### STAFF REPORT

PCA 86-S-071-04 and RZ/FDP 2015-SU-002  
(Concurrent with DPWES RPAE 7265-WRPA-002-1  
and WQIA 7265-WQ-001-1)

# TRINITY CENTRE - PARCEL 12A

## CONCEPTUAL DEVELOPMENT PLAN FINAL DEVELOPMENT PLAN

Figure 5: Proposed site layout.

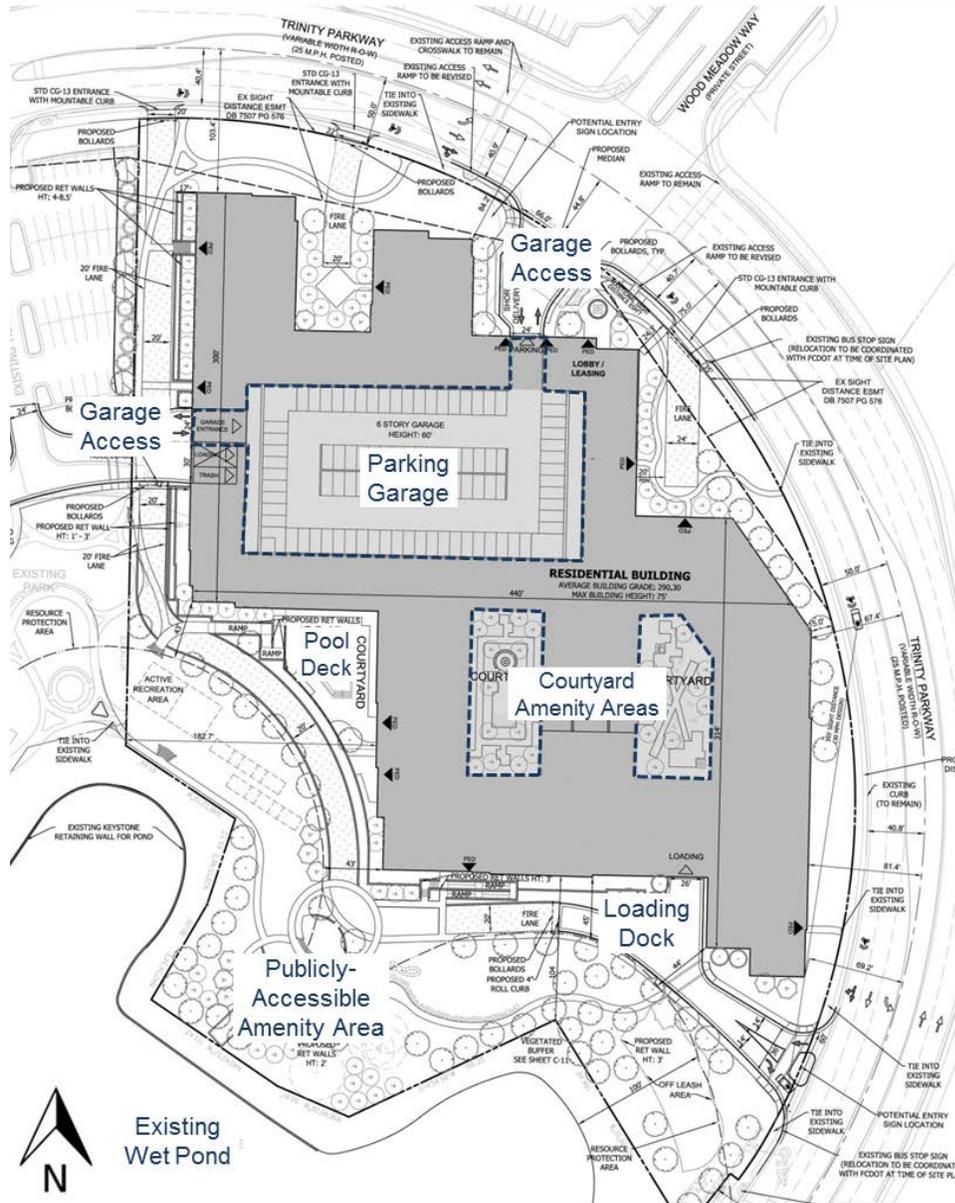
The development plan for the 7.08-acre parcel includes one large, 4-story, 355-unit apartment complex, with internal parking garage and courtyard areas, occupying the majority of the site, with a publically-accessible amenity area and vegetative buffer adjoining the existing Trinity Lake, to the south of the parcel.

Figure 11: Proposed off-site improvements.

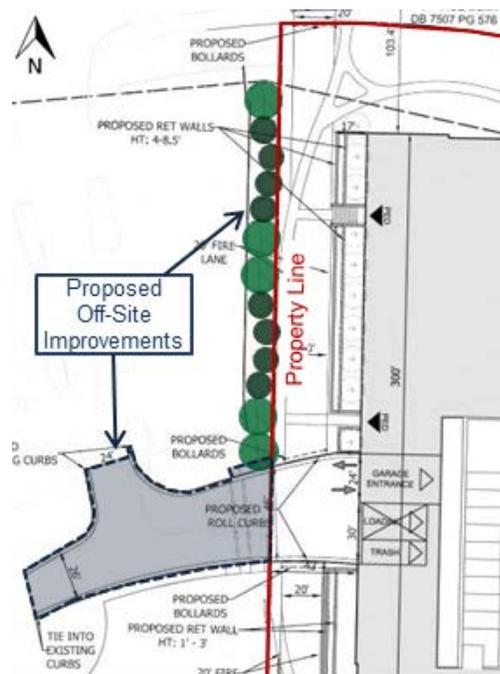
The applicant is not required to provide screening of the proposed residential use to the more intensive office use to the west (which is currently under the same ownership as the application parcel), but the proposed conversion of office use to residential might potentially result in a requirement for the neighboring office use to provide transitional screening to the residential use, at such time as that parcel might seek redevelopment or intensification of its use. To mitigate this potential concern, the current applicant has proffered to install vegetative screening material on the neighboring property (subject to applicable easements) to screen the parking area from the residential use. A zoning interpretation request has been submitted by the applicant to clarify that such off-site landscaping would remain in conformance with approved development plans, and is currently under review.

Figure 17: BMP treatment areas, as specified on the CDP/FDP.

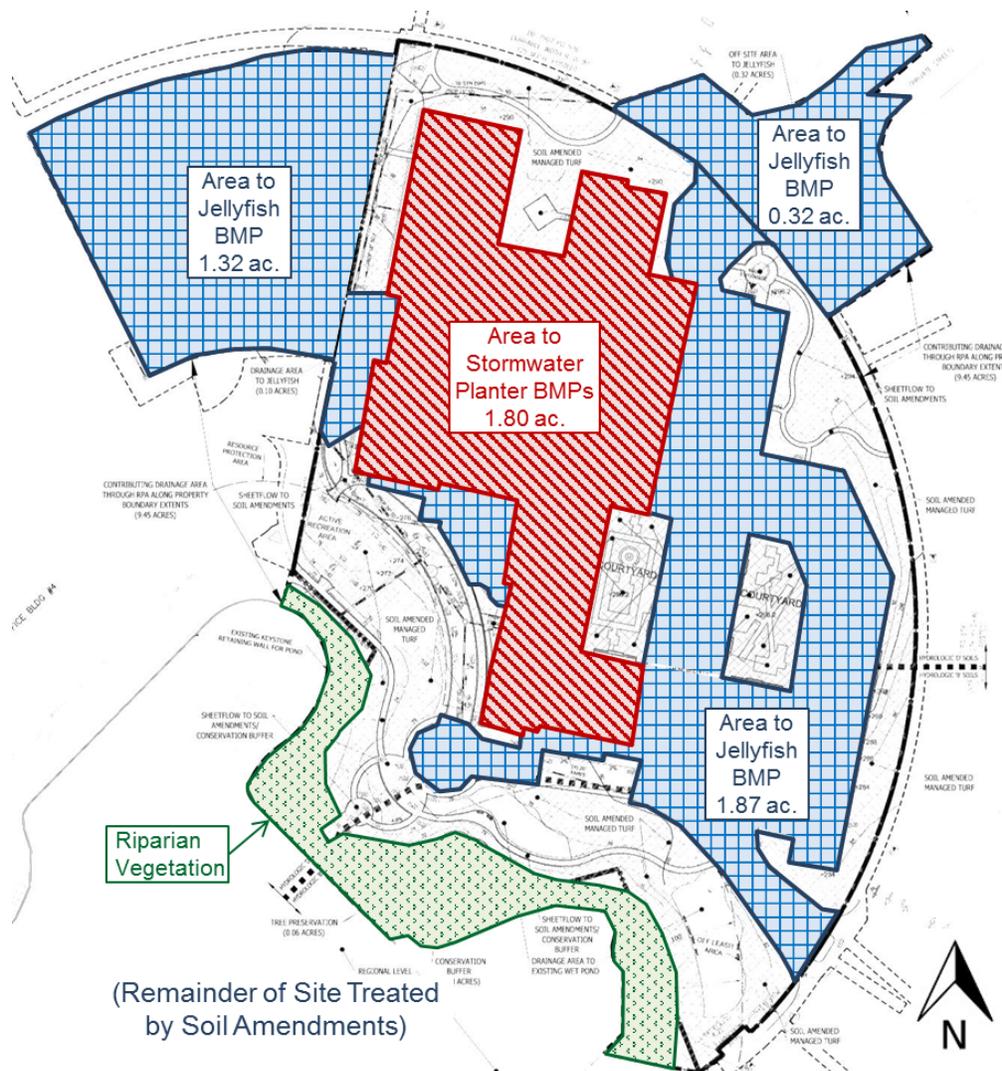
The existing wet pond captures the stormwater runoff from the entire site and was designed to meet similar water quality goals at the time of the previous approval. In addition, the applicant specifies the use of stormwater planters, manufactured BMP's, and soil amendments on the CDP/FDP, in order to meet higher redevelopment standards, and to provide additional SWM and water quality benefits. Utilizing the Virginia Runoff Reduction Method spreadsheet to evaluate pre and post-development stormwater conditions (Sheets C-12 and C-12a of the CDP/FDP), the applicant demonstrates preliminary compliance with the requirements of the Stormwater Ordinance, and the 50 percent reduction requirement of the WSPOD Ordinance. Review and approval of the final Water Quality plan would be evaluated by DPWES at the time of site plan review.

Figure 20: Detail of plaza and children’s play areas.

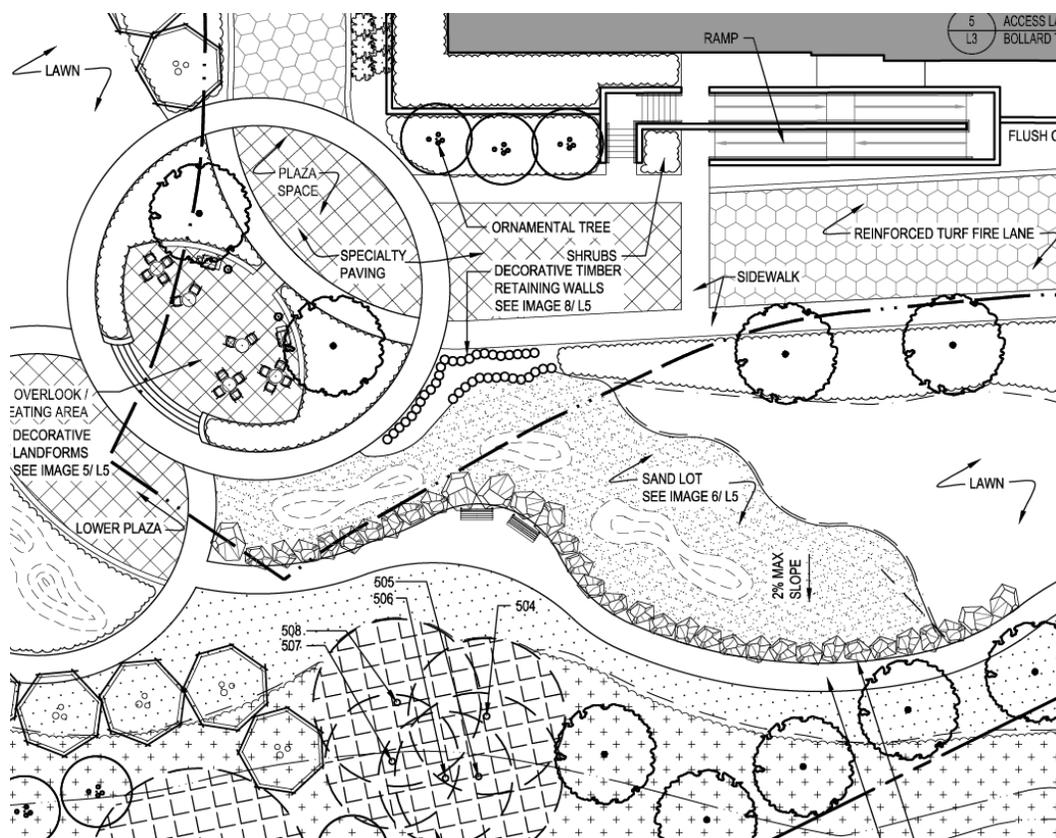
Comprehensive Plan (and Zoning Ordinance) guidance direct an applicant to provide ample opportunities for active recreation on a site. As described in the Description of Proposal section of this report, the proposal includes a number of residential amenities as well as a large portion of the site that is dedicated to a publically-accessible outdoor amenity area, including walking/running trails throughout the site and grassed areas suitable for more structured play. In response to staff requests to provide additional opportunities for active recreation on the site, the applicant has included additional play fields, as well as “natural” children’s play features, including earthen mounds, a sand play area, and timber climbing features.
